Doc No.: TN20-52
Version: 1.0
Date: 20th March 2003
Subject: P170 (MC224) and SLM compatibility Issue

Technical Bulletin

Fig 1: MC224 Main Board

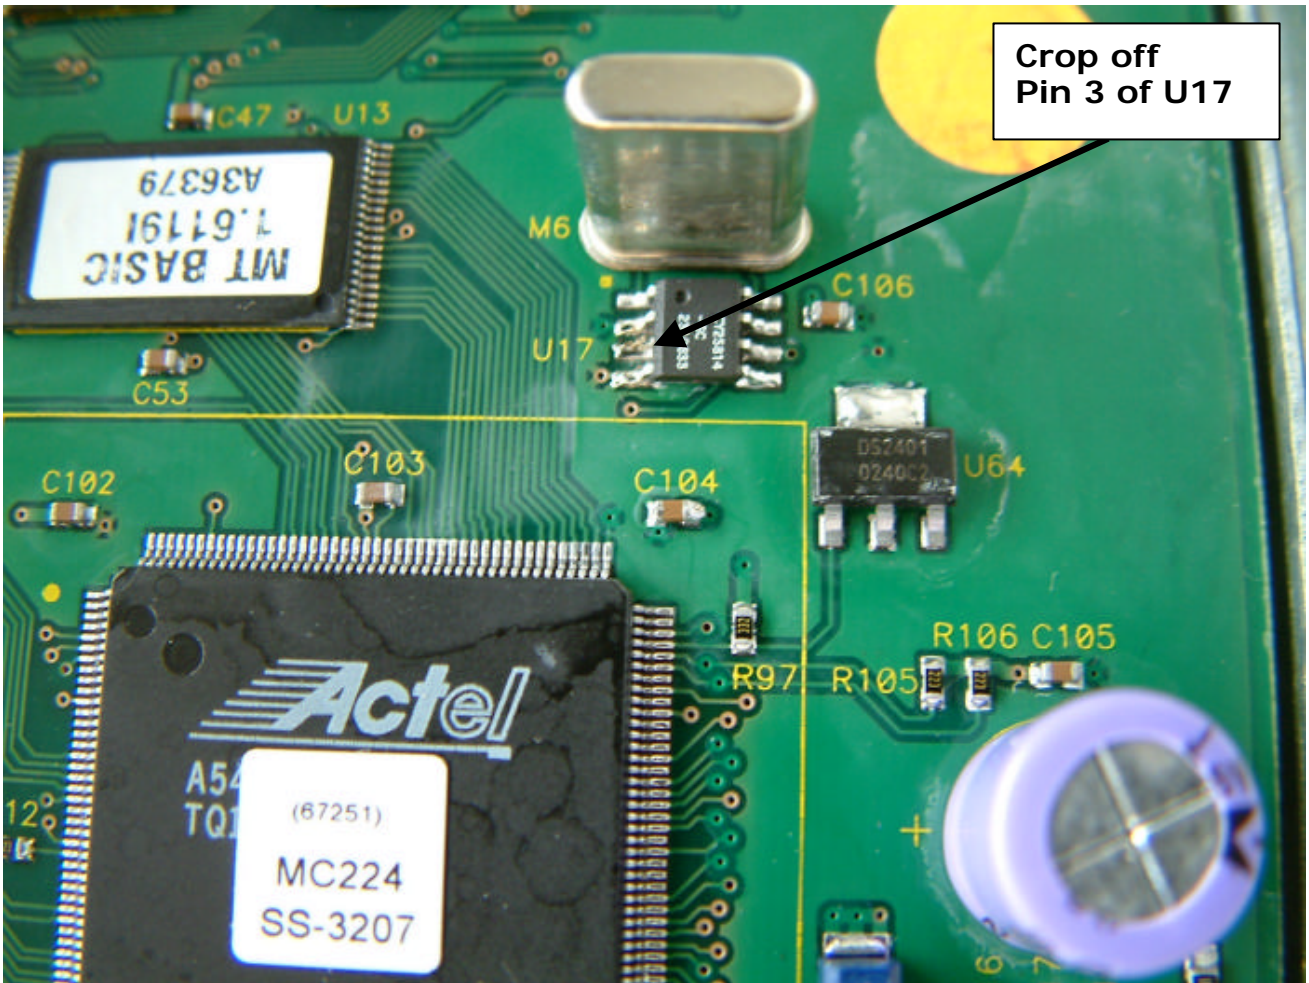
For boards already in the field a simple change can be made to the P170 to improve the accuracy of the sync signal. By isolating pin 3 of U17 the spread of the clock is reduced and the 1ms sync signal is brought within a range that will work reliably with the DriveLink^{MD} ASICs. The trade off is a possible increase in emissions. Comparative checks were made between a modified and unmodified board and no significant increase in emissions was seen.

The easiest way to affect this change is to crop the pin of the IC as shown overleaf:

When the modification has been done, the system software must be updated to 1.6126 or later.
